CITY OF BROOK PARK, OHIO

ORDINANCE NO. 11401-2024

**AN ORDINANCE
AUTHORIZING THE INCLUSION OF ORNAMENTAL PATHWAY
LIGHTS AND AN AERATING FOUNTAIN IN THE WEDO PARK
STORM WATER BASIN PROJECT (CONTRACT 202211),
AND DECLARING AN EMERGENCY**

GEMINI SURFACE SPRAY AERATOR

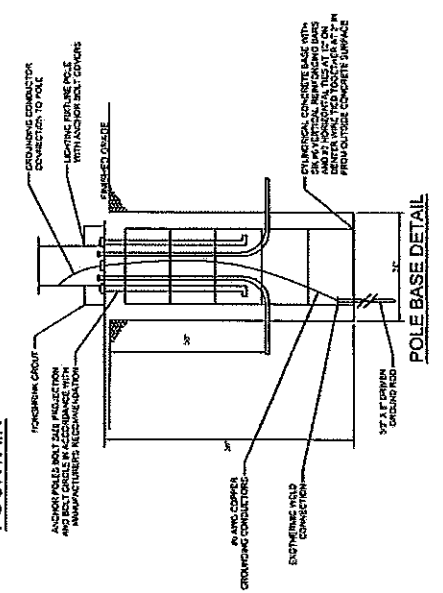
WHEREAS, it is recommended that an aerating fountain be installed as a natural solution to water quality management, controlling algae growth, aquatic weeds and possible odors;

SECTION 2: The estimated cost for the additional work has been estimated not to exceed \$95,000 for the pathway lights and \$48,000 for the fountain.

MODELS: The motor shall be a floating surface spray aerator with a "turret" shaped spray pattern. Spray dimensions are 9 feet (2.74 m) in height, and 15 feet (4.57 m) in diameter.

PUMPING CAPACITIES: The primary pumping rate of the unit is 365 GPM (1.36 m³/hr) and the secondary or reduced circulation rate is 9.650 GPM (0.36 m³/hr).

MOTOR: The motor shall be a 2 HP, 230 volt, 1 phase, 60 Hz oil-cooled, submersible motor operating at 3450 RPM or 50. The motor shall be 1.15 except for 304 1/2 inch shaft size. The motor shall be protected from the elements and shall be dynamically balanced. The motor shall be dynamically balanced. The winding (motor) shall be covered with class F rated insulation designed for complete immersion in oil. The motor shall be attached to a thermoplastic motor base plate. The motor shall be protected against oil and water leakage by a combination of rotary seals, stationary seals, and molded rubber "O" rings. Motor shall be serviceable.
